CONSOLIDATION COAL CO.

EMERY DEEP MINE

MID-TERM PERMIT REVIEW

Re: Mid-Term Permit Review, Emery Deep Mine, ACT/015/015

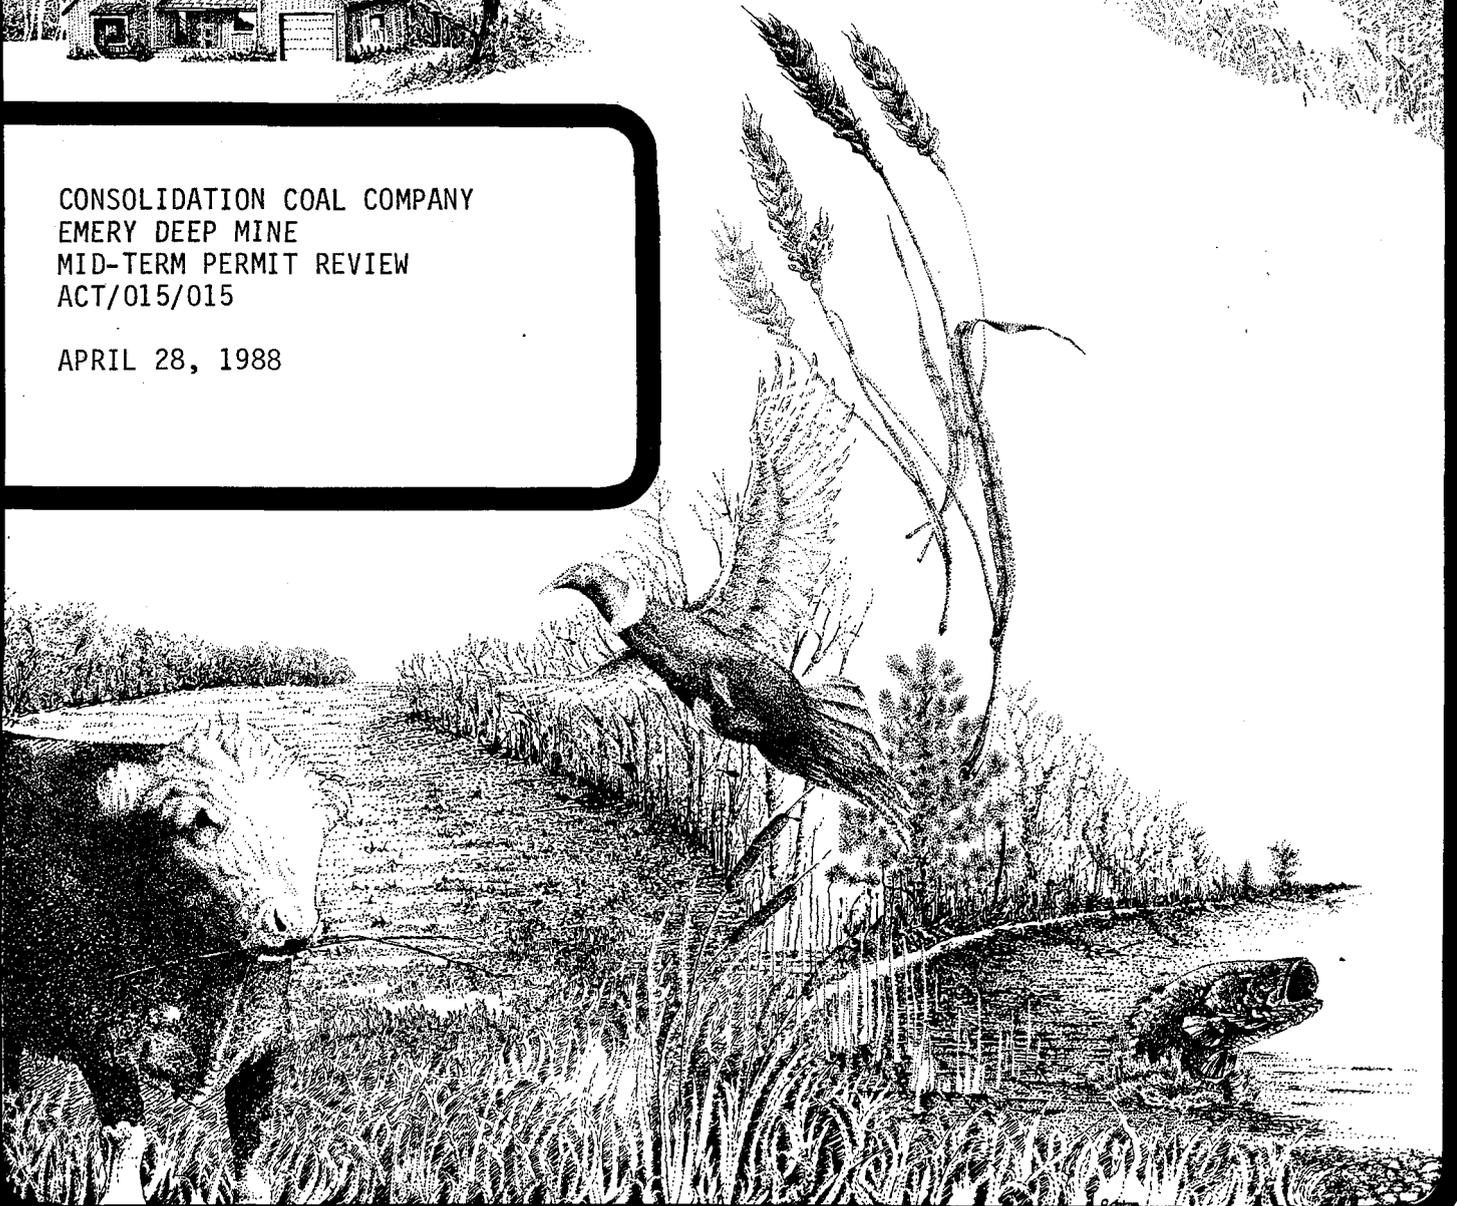
3. All new areas of disturbance should be shown on Plate 3-3, Chapter 3, of the operator's MRP. This would include the northwest coal storage area, sediment ponds, and any areas disturbed for topsoil salvaging on proposed sites.

Refer to revised Plates 3-2 and 3-3 enclosed with this submittal. Plate 3-2 shows changes to building and trailer locations in the mine yard area. Plate 3-3 shows the additional areas of disturbance.
